**Stage 1/2 Road Safety Audit
Proposed Residential Development
Cullairbaun, Athenry, Co. Galway**

Client:	Galway County Council
Document No:	242462-ORS-XX-XX-RP-TR-13g-001

Revision	Status	Author:	Reviewed by:	Approved By:	Issue Date
P01	S2	JI	DMcC	MG	28/03/2025
P02	S2	JI	DMcC	MG	08/04/2025

Problem No.01: Sightline Availability

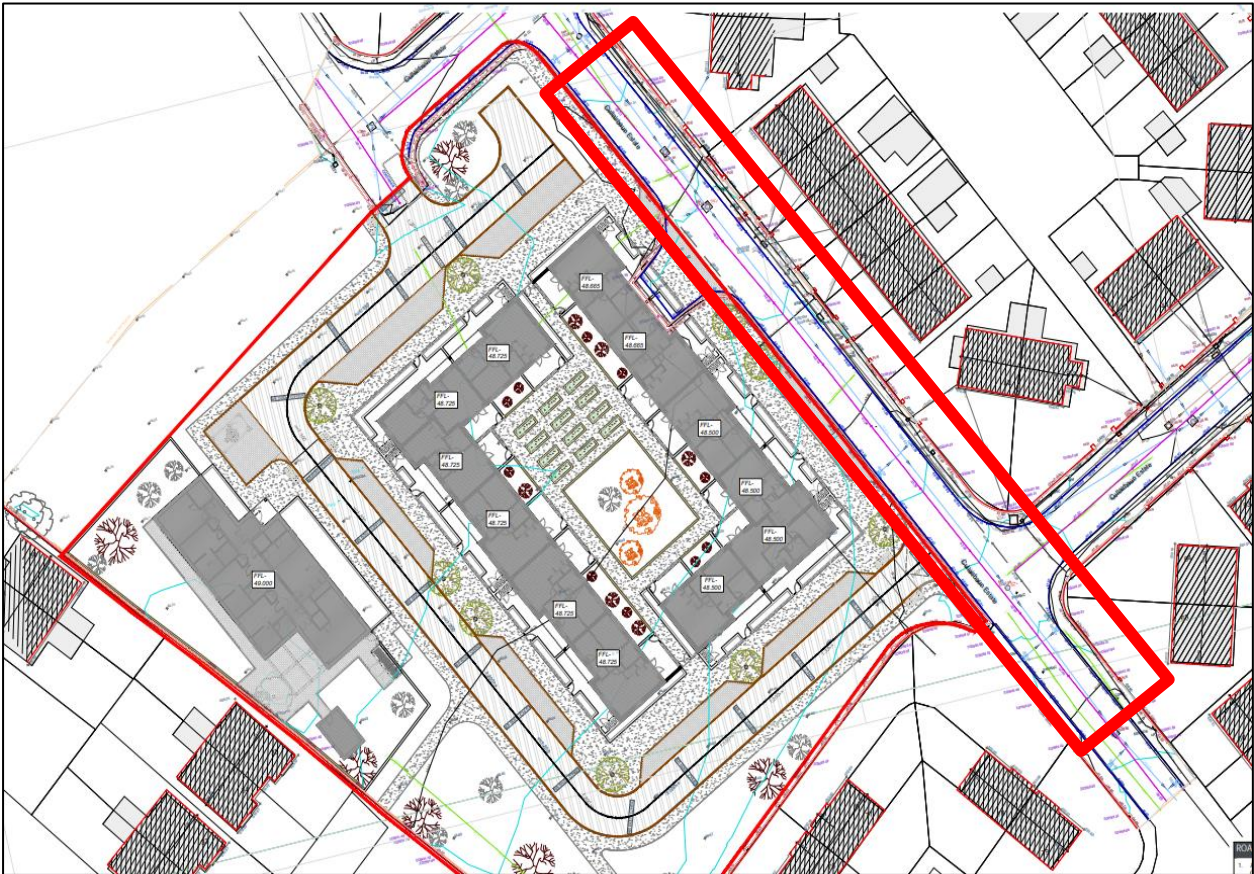
Location: Proposed Development Entrances

The audit team note that there are no sightlines in the drawings provided to demonstrate that appropriate sightlines can be achieved when vehicles are exiting the development. The audit team is concerned that the appropriate sightlines cannot be achieved as boundary treatments and parked cars along the carriageway may obstruct visibility at the junctions. This could result in vehicles encroaching onto the main carriageway into the line of oncoming vehicles which could lead to sideswipe or side impact type collisions.

The design team should ensure that clear visibility is provided in both directions and that visibility envelopes are clear of any obstacles such as street furniture and boundary walls.

Problem No.02: Speed Control Measures

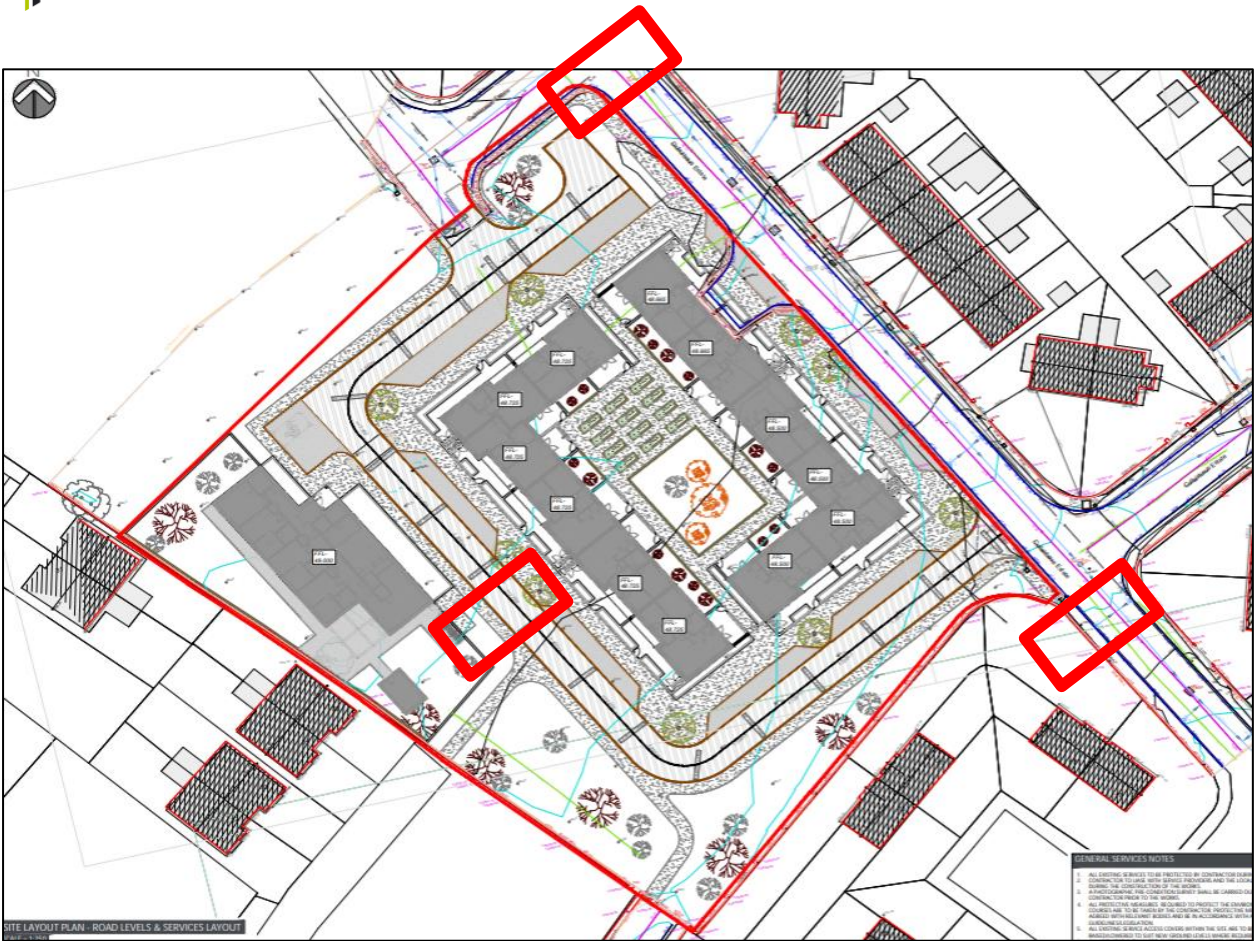
Location: Throughout the Scheme

The audit team note from the drawings provided, that there is a lack of speed control measures proposed within the scheme. The audit team are concerned that the layout as its currently presented could encourage higher speeds which could put vulnerable users within the development at risk. Should a collision occur there is a high risk of injury to the vulnerable user.

The design team should ensure that appropriate speed control measures are incorporated within the development to reduced vehicular speeds.

Problem No.04 Location of Uncontrolled Crossing

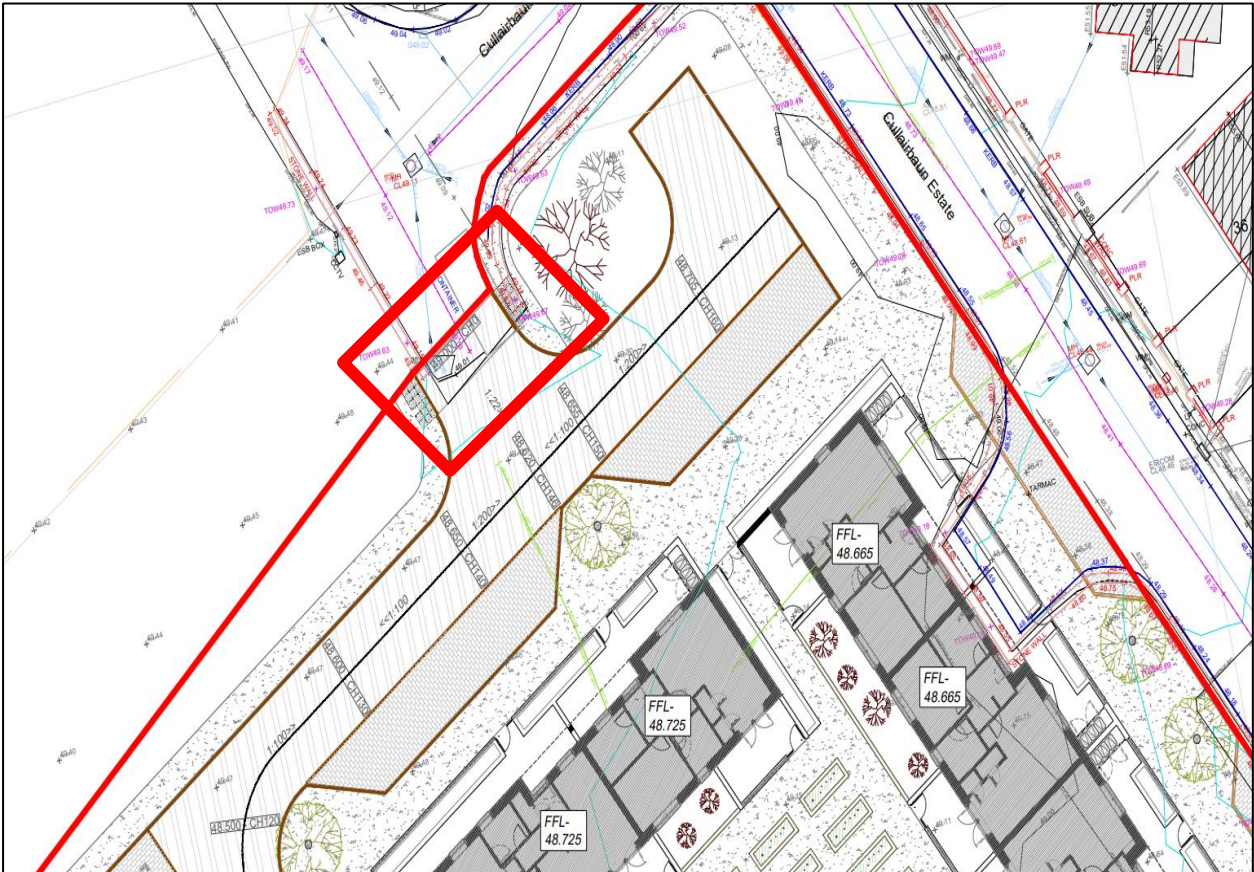
Location: Location Identified

The audit team note from the drawings provided that the proposed uncontrolled crossing appears to be on the sloped section of the raised table. This position of the crossing leads to an uneven surface particularly for mobility impaired pedestrians which could result in slips, trips and falls at the crossing location which could lead to injury.

The design team should provide the uncontrolled crossing at an appropriate location.

Problem No.05: Accessibility of Wheelchair Parking Space

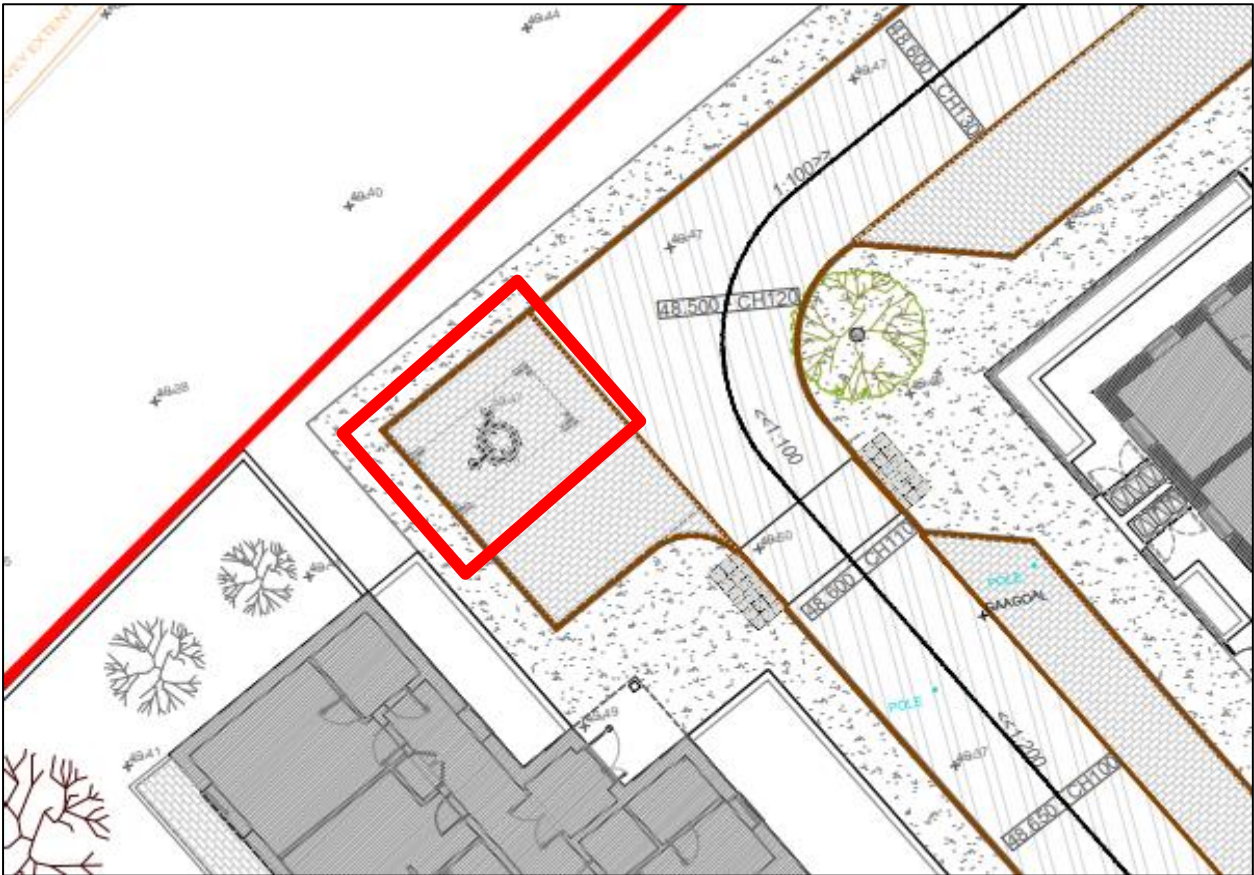
Location: Disabled Parking Space Identified

The audit team note from the drawings provided, that there is a wheelchair accessible parking space provided within development. It is not clear from the drawings provided as to how users of this space will access the footpath and may have to use the roadway to access the nearest dropped kerb. Dropped kerbs should be provided at disabled parking spaces to allow accessibility for users.

The design team should provide details on the proposed access from the wheelchair accessible parking space to the footpath allowing for adequate level landings behind the dropped kerbing.

Problem No.06: Restricted Car Parking Spaces

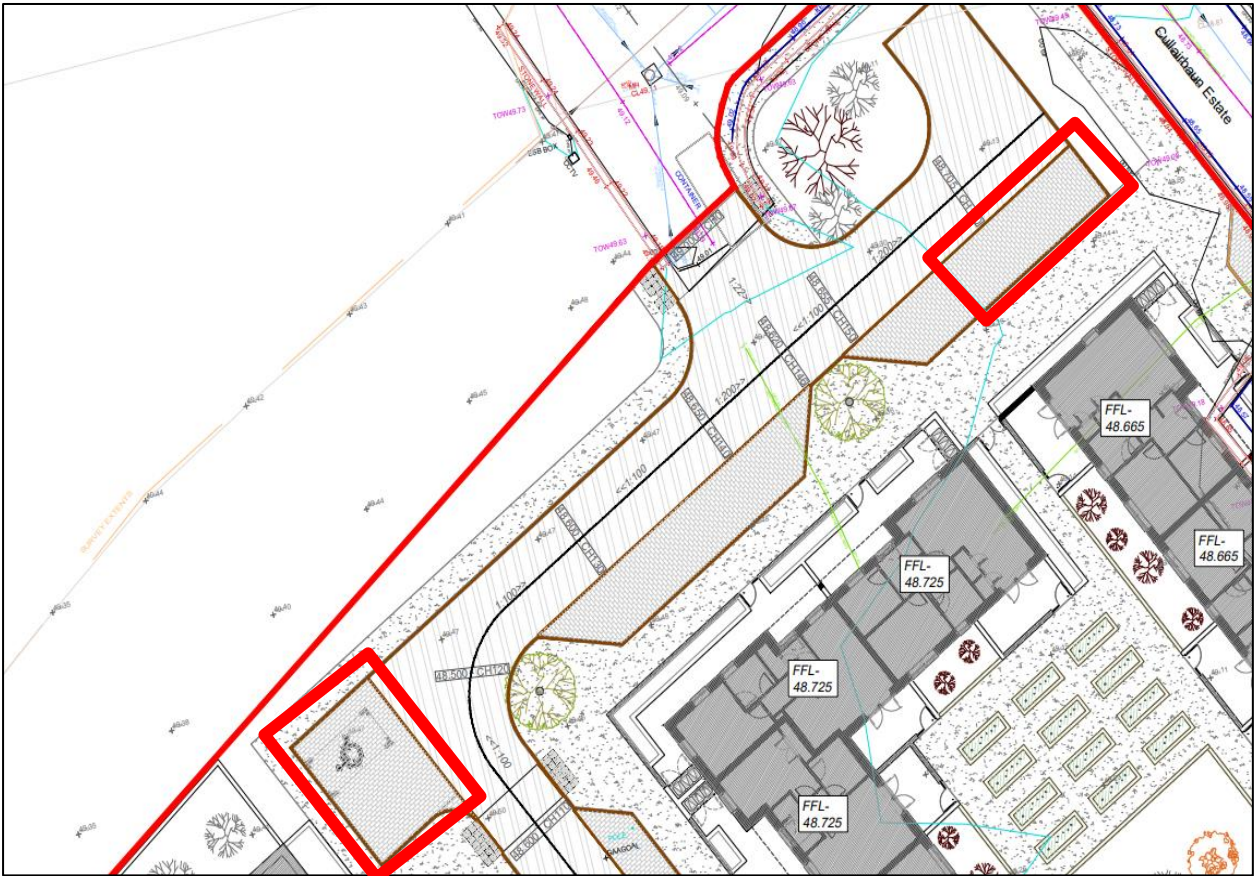
Location: Location Identified

The audit team observes from the provided drawings that the parking spaces have limited manoeuvring space behind the bays, which may restrict vehicles from executing reverse manoeuvres effectively and turning onto the road. This constraint could increase the risk of conflicts between vehicles and vulnerable road users and vehicles entering the development, as drivers may need to reverse over extended distances to exit the spaces, thereby elevating the risk of collisions.

The design team should reassess the geometry of these parking spaces to address the identified safety risks and ensure that vehicles can safely manoeuvre in and out of the spaces.

Problem No.07: Corner Radii within the Scheme

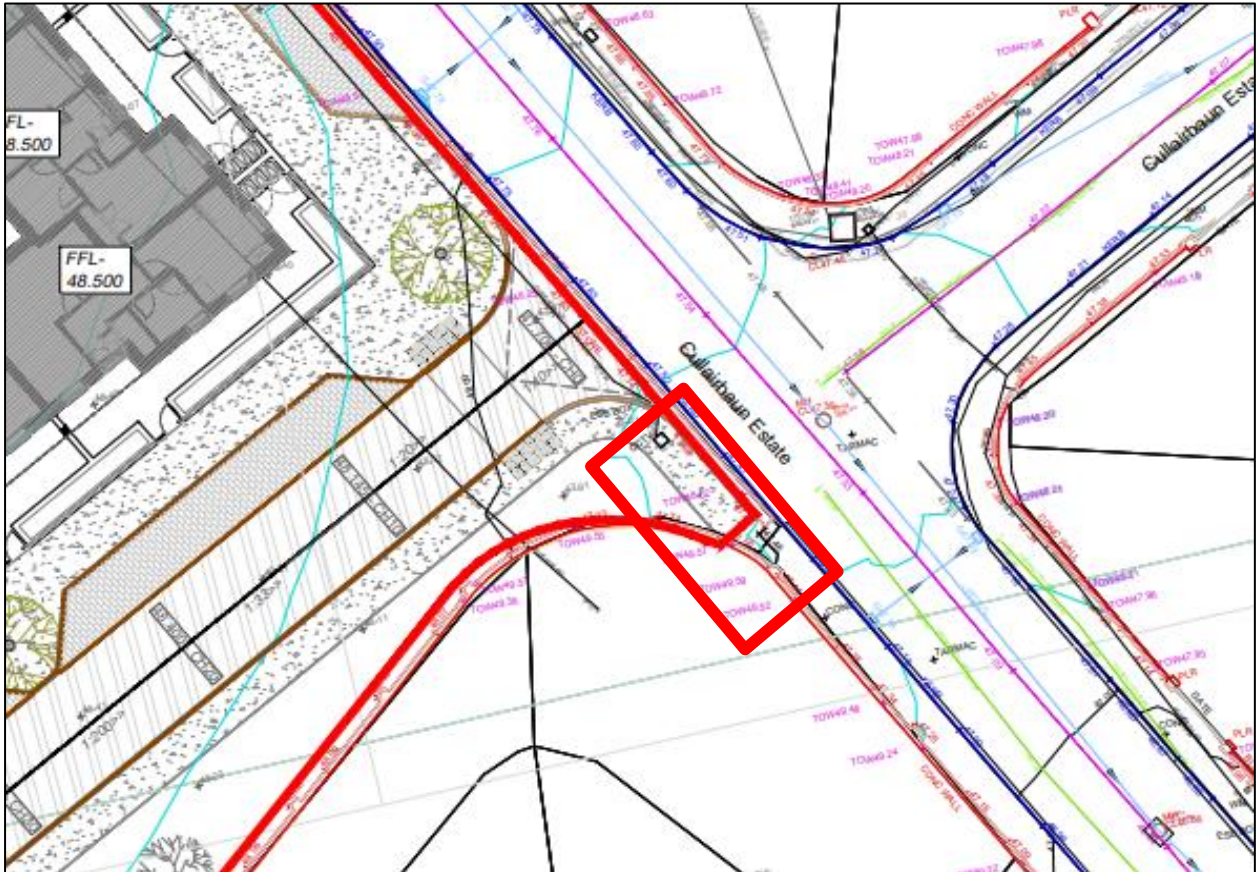
Location: Locations Identified

The audit team note from the drawings provided that the corner radii appear to be excessive which could increase the potential for higher vehicle speeds within the development. The audit team has concerns, that vehicles would not be encouraged to slow down and could result in collisions with vulnerable road users at the uncontrolled crossings.

The design team should ensure that the corner radii is appropriate for the design speed to slow vehicles down.

Problem No.09: Tie-in for New Footpath

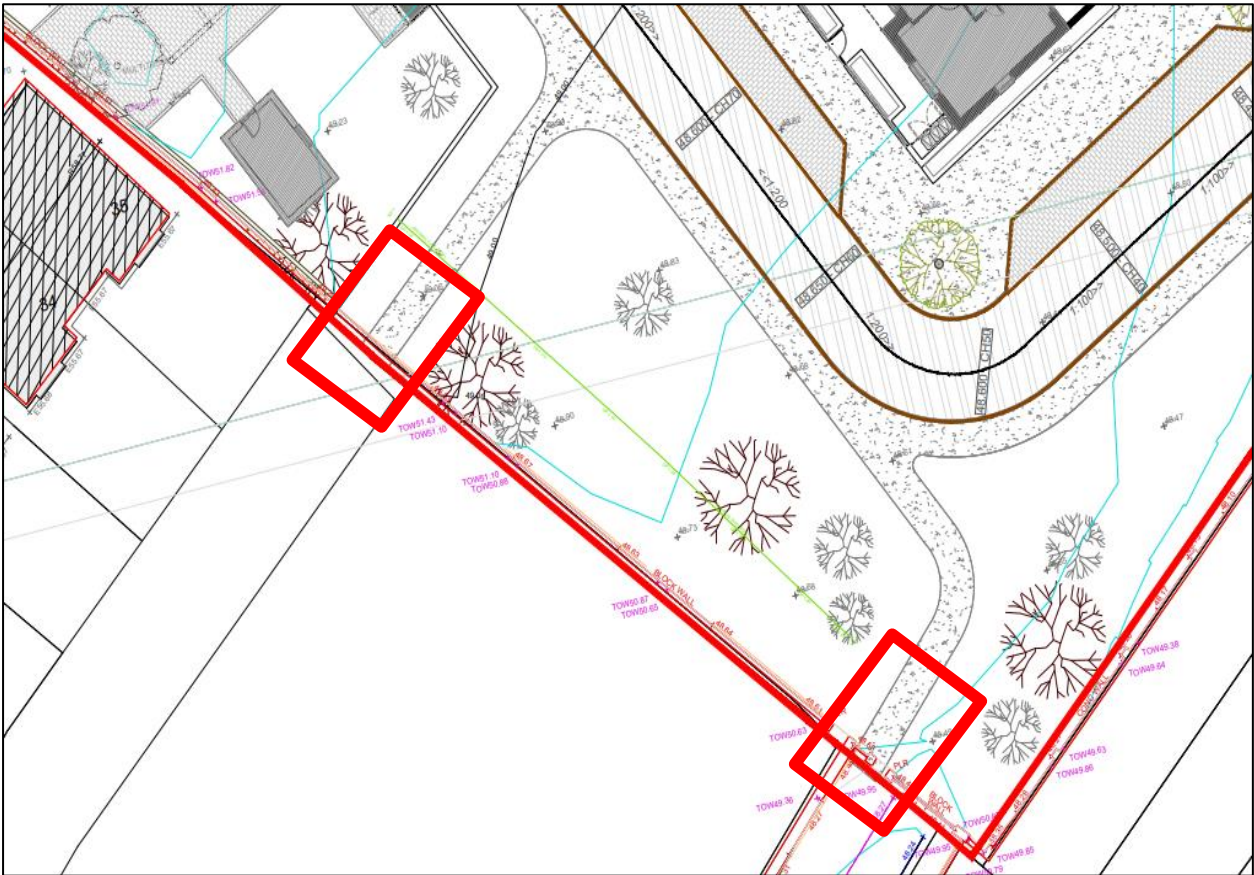
Location: South of the Proposed Development

The audit team note from the drawings that the proposed footpaths terminate at the southern end of the site, however there is no existing footpath at these locations to tie into. Lack of tie-in to an existing footpath could lead to pedestrian confusion, who may enter the roadway to cross at a location without suitable pedestrian facilities. This has the potential to cause collisions between pedestrians and vehicles.

The design team should ensure that the proposed footpaths tie in with existing pedestrian infrastructure at these locations.

Problem No.10: Landscaping and Boundary Treatment

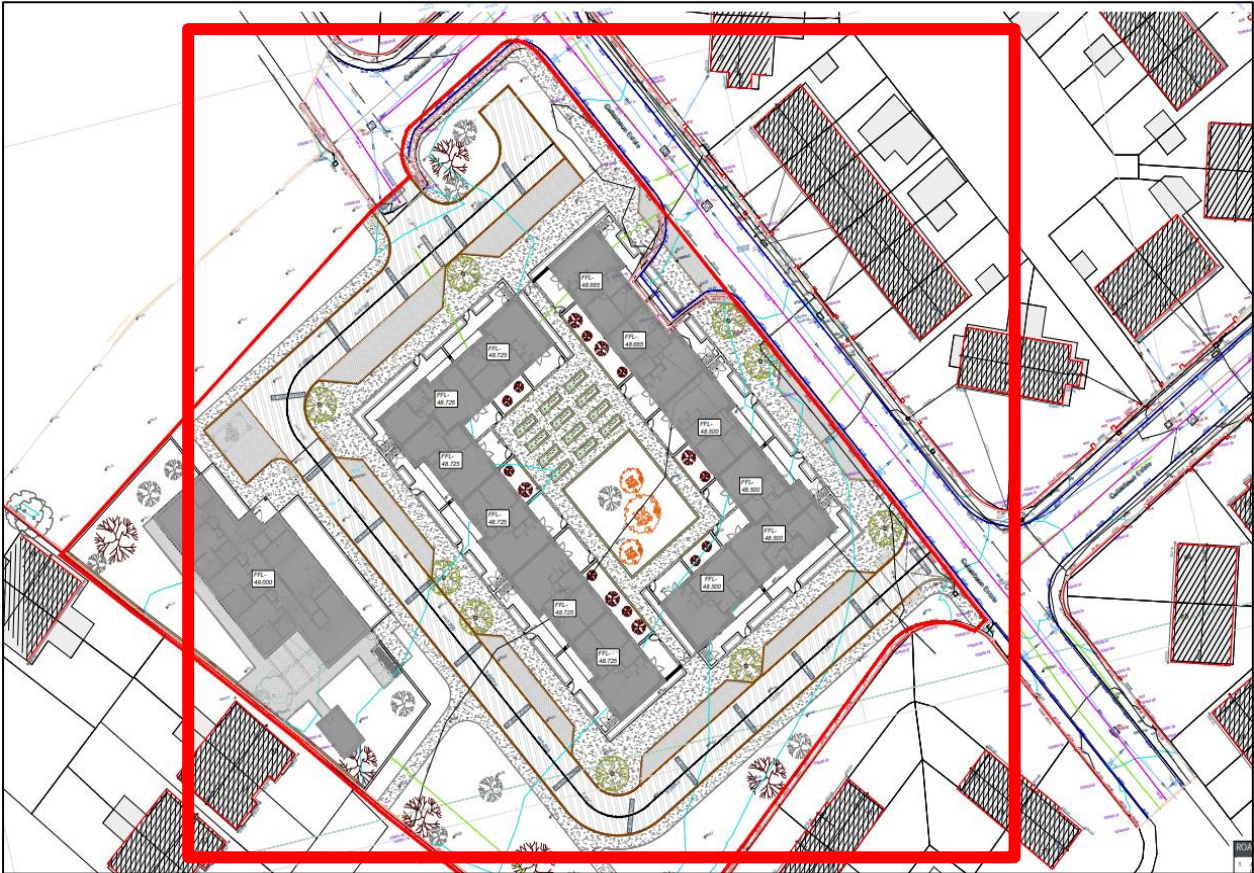
Location: Boundary of Scheme

The audit team note from the drawings provided, that there are parking spaces along the sides of the proposed development. If a vehicle must reverse out of these spaces and boundary treatments and landscaping if positioned incorrectly could hinder visibility. There could potentially be an increase in the number of collisions with pedestrians and/or side impact type vehicle collisions. This poses a significant risk of injury to pedestrians and vehicle occupants.

The design team should ensure that boundary treatments and landscaping do not hinder visibility for vehicles exiting these parking spaces. The design team should also ensure that landscaping does not restrict sightline availability at crossing points, junctions, and forward visibility for vehicles.
